PETITION FOR VARIANCE
15th Election District

RE: PETITION FOR VARIANCES : BEFORE THE ZONING COMMISSIONER
NE/S of North Point Blvd.
476' SE of Rosebank Ave.
(3862 North Point Blvd.) : OF BALTIMORE COUNTY
15th District :
JOSEPH J. PIROG, JR., : Case No. 86-92-A
et ux, Petitioners

SITE PLAN	
for VARIANCE PETITION	
Proposed Addition to	
WALTER JAY'S AUTO PAINT	
3862 NORTH POINT BLVD	
BALTO. MD. 21222/Elect Dist 15	
Scale: 1" = 50'	Date: 5/10/85
BY: G. D. McLELLAN & ASSOC.	4/1-9136

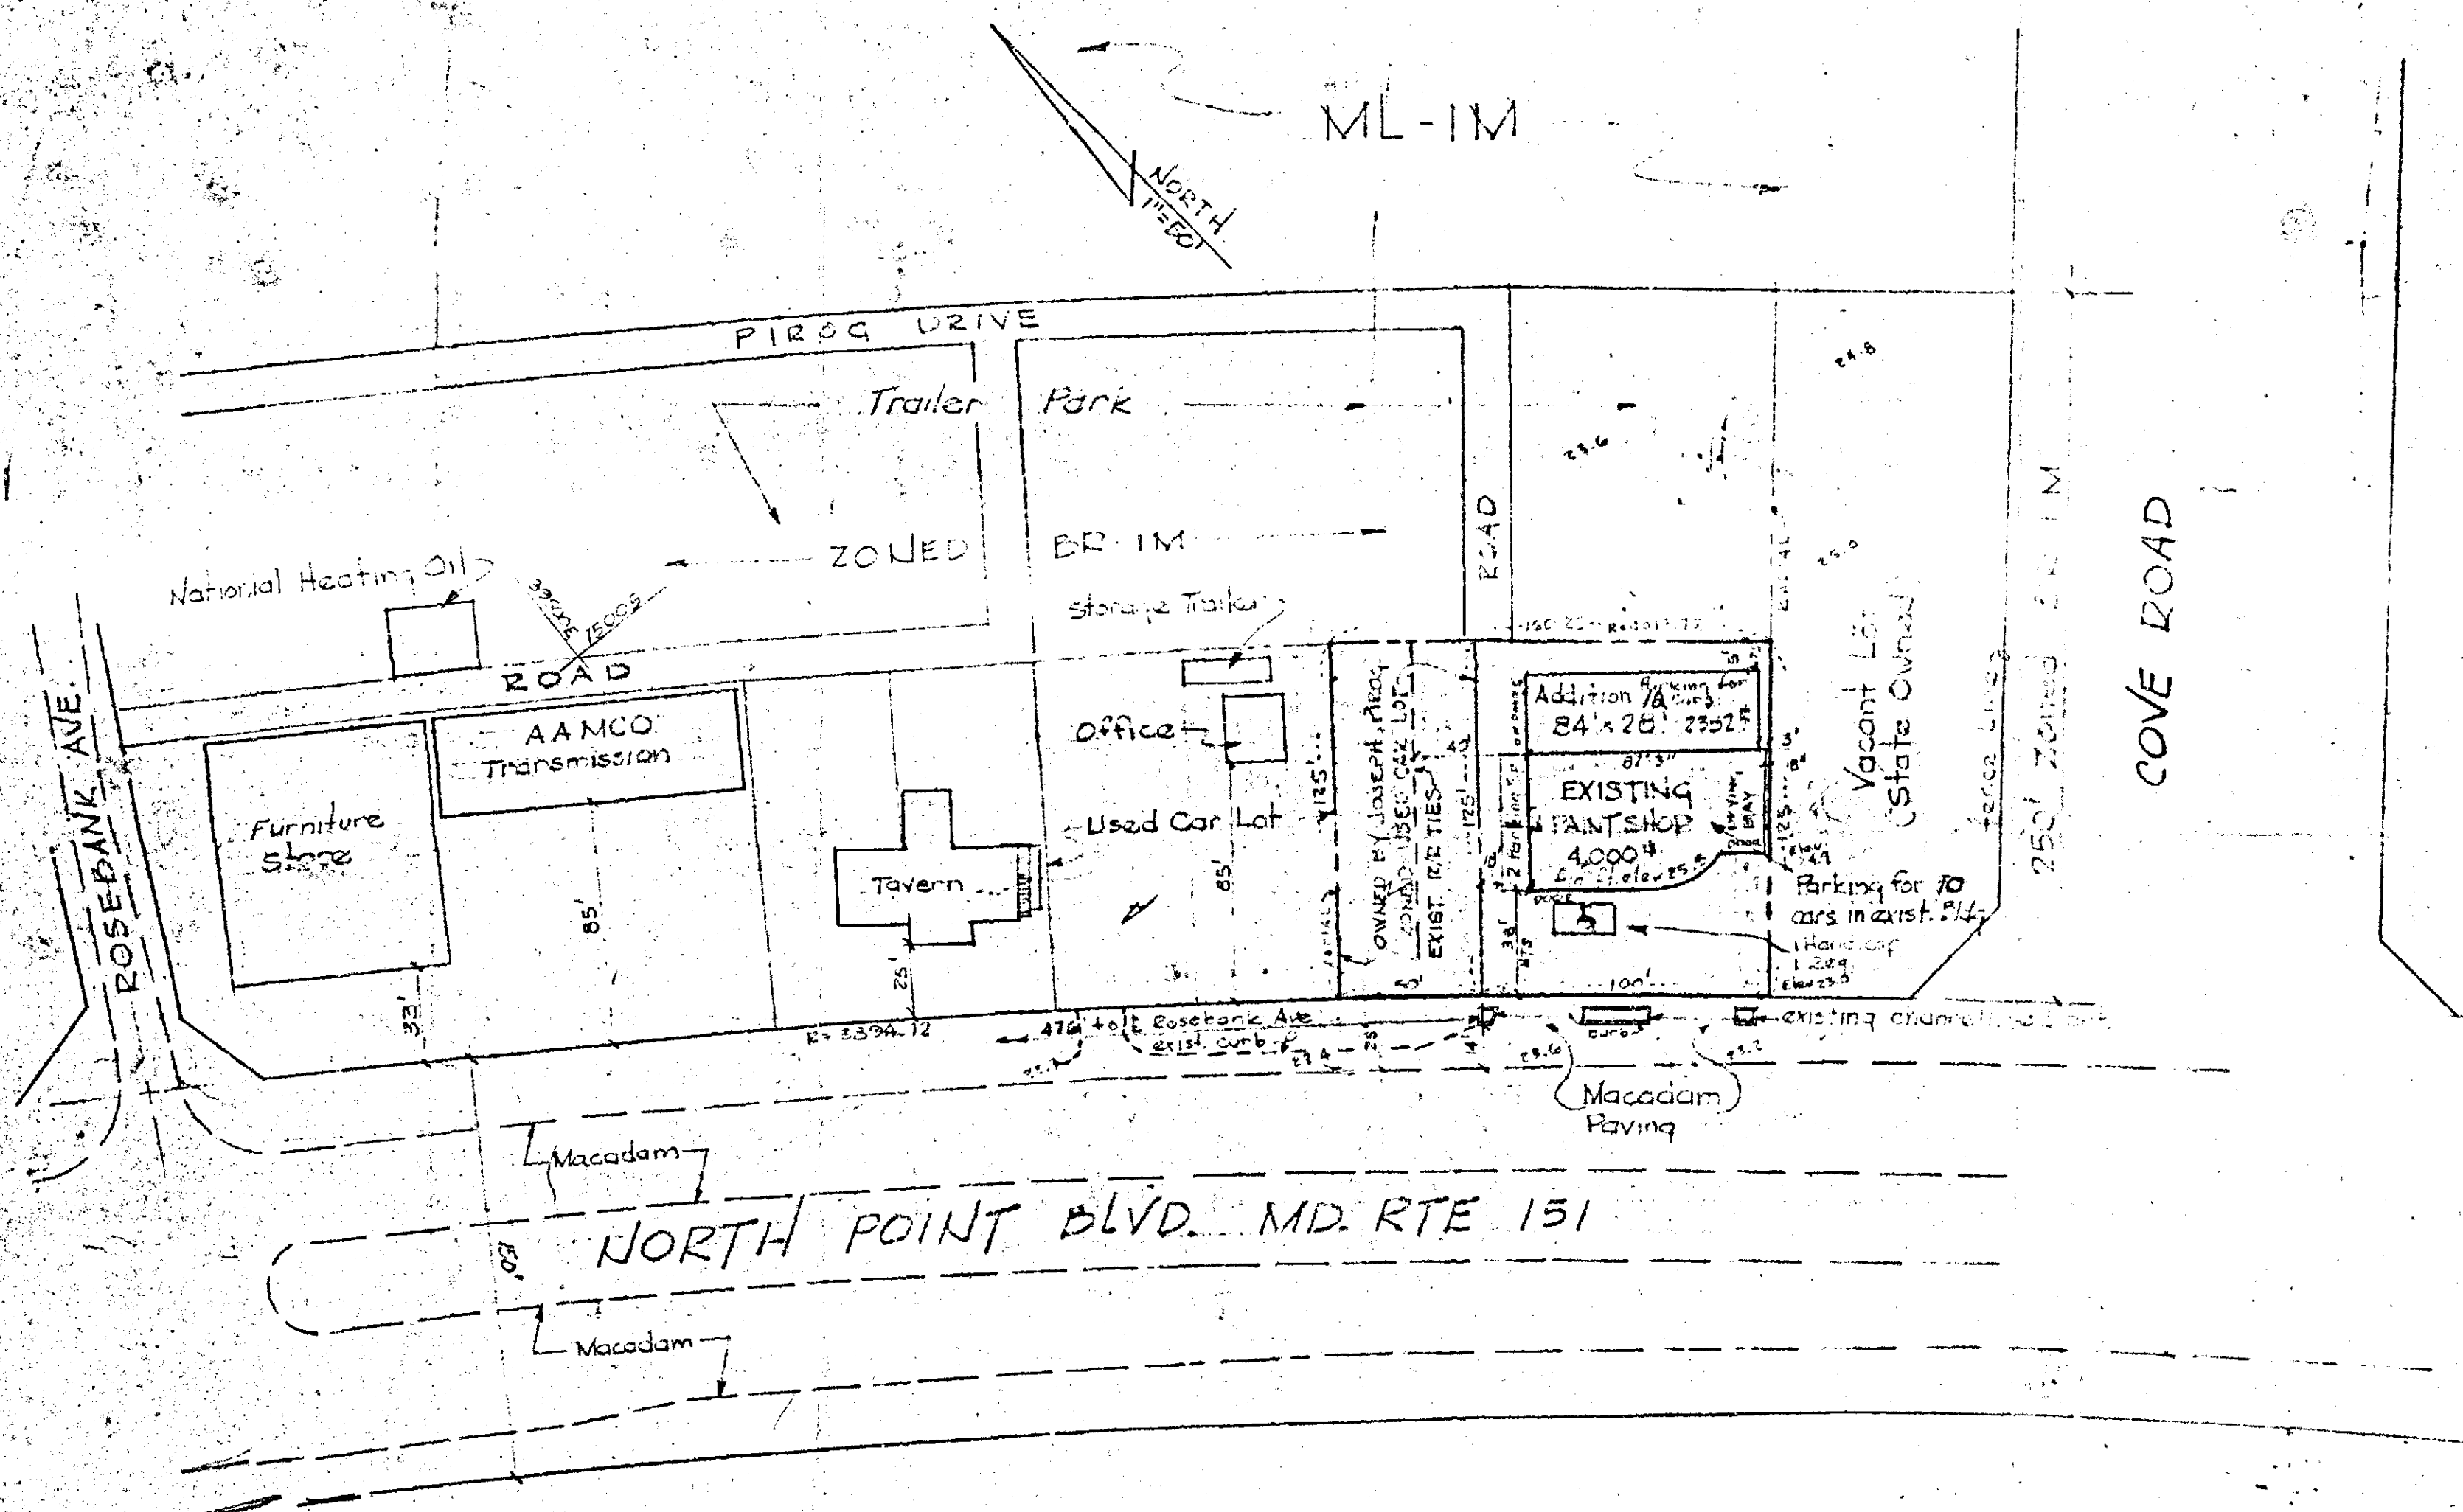
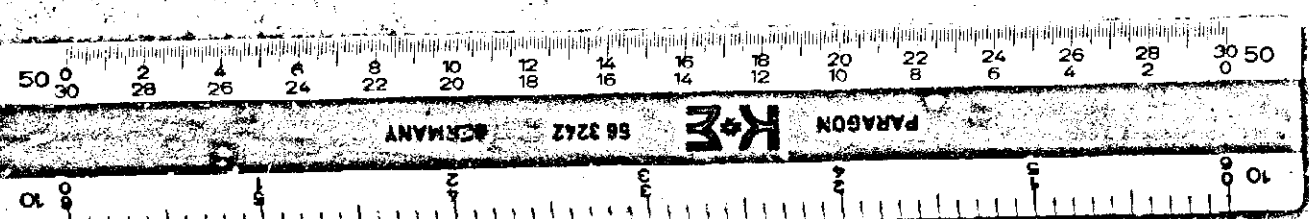
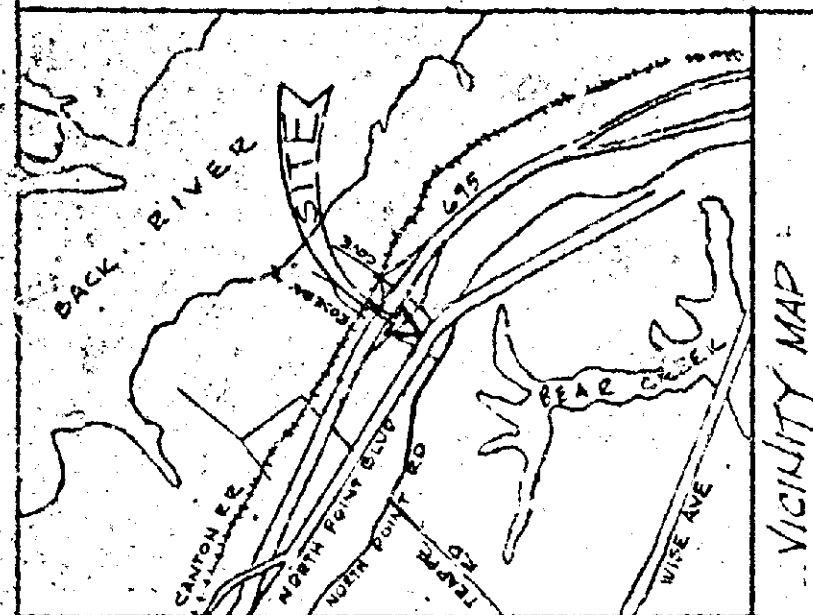
1. The addition shall be no larger than 62' x 27'; no portion shall be closer than 5 feet to the rear property line and 5 feet to the southeast property line dividing the subject property from that owned by the State of Maryland.

2. There shall be no openings in the rear wall of the addition. Windows on the ends (southeast and northwest) and skylights shall be fixed. Ventilation shall meet all requirements of the Department of Health and shall discharge to the southeast. Doors shall remain closed except for entry and exit.

3. Hours of operation shall not extend beyond 7:30 a.m. and 6:00 p.m.
4. All requirements of the Baltimore County Landscape Manual shall be met. Live evergreen screening to reach a height of 10 feet within 4 years shall be planted between the addition and the rear property line. Landscaping shall be added to the front of the building.

8. A drawing of the interior of the existing building and the addition showing bulky and permanently attached equipment, as well as parking spaces, shall be submitted to and approved by the Office of Zoning prior to the issuance of building permits. Access to the building and addition shall be granted to county inspectors to insure that indeed such parking spaces are available.

9. All parking spaces shall be striped. Parking in areas not indicated as parking spaces on the approved plan shall constitute a zoning violation in that it will be non compliance with an approved site plan.

SITE PLAN
for VARIANCE PETITION
Proposed Addition to
WALTER JAY'S AUTO PAINT
3862 NORTH POINT BLVD
BALTO MD 21222/Elect Dis: 15
scale: 1" = 50' date: 5/10/85
P. G. M. McLELLAND & ASSOC. 477-9136

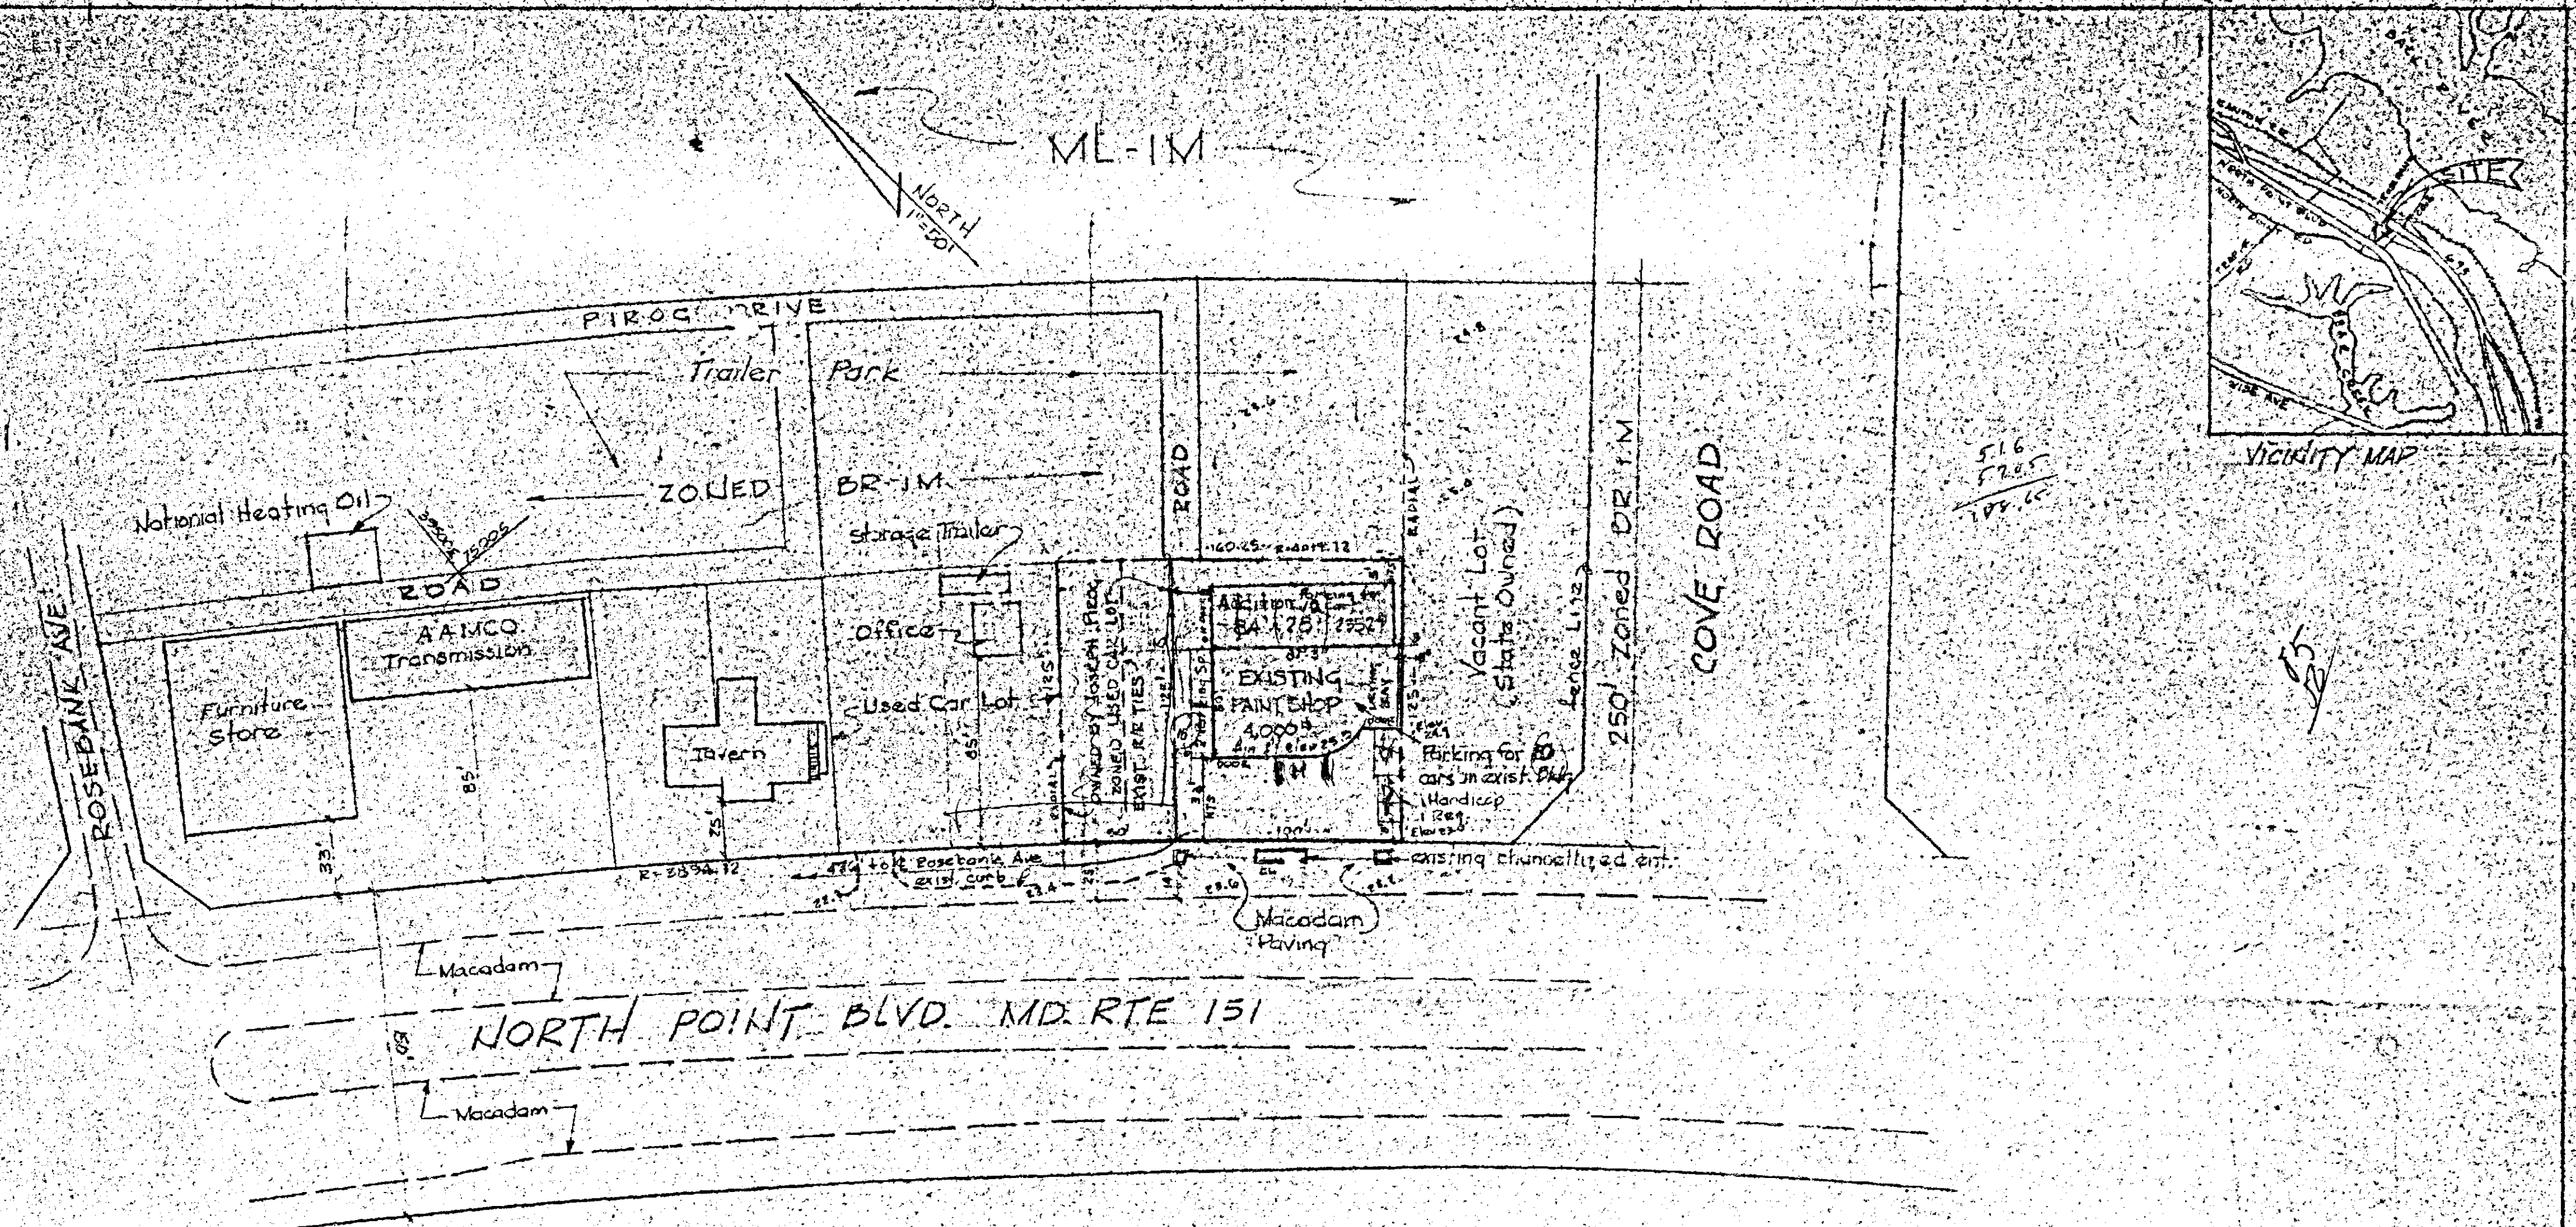
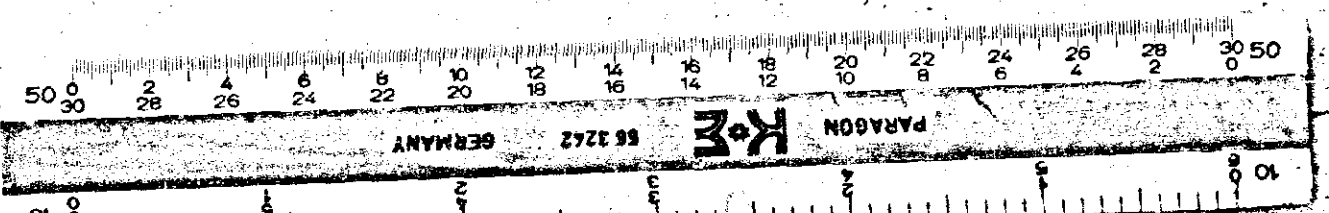
- ☒ There are no site planning factors requiring comment.
- ☒ A County Review Group Meeting is required.
- ☒ This site is part of a larger tract; therefore it is defined as a subdivision. The plan must show the entire tract.

- ☒ A record plat will be required and must be recorded prior to issuance of a building permit.
- ☒ The access is not satisfactory.
- ☒ The circulation on this site is not satisfactory.

- ☒ The parking arrangement is not satisfactory.
- ☒ Parking calculations must be shown on the plan.
- ☒ This property contains soils which are defined as wetlands, and development on these soils is prohibited.
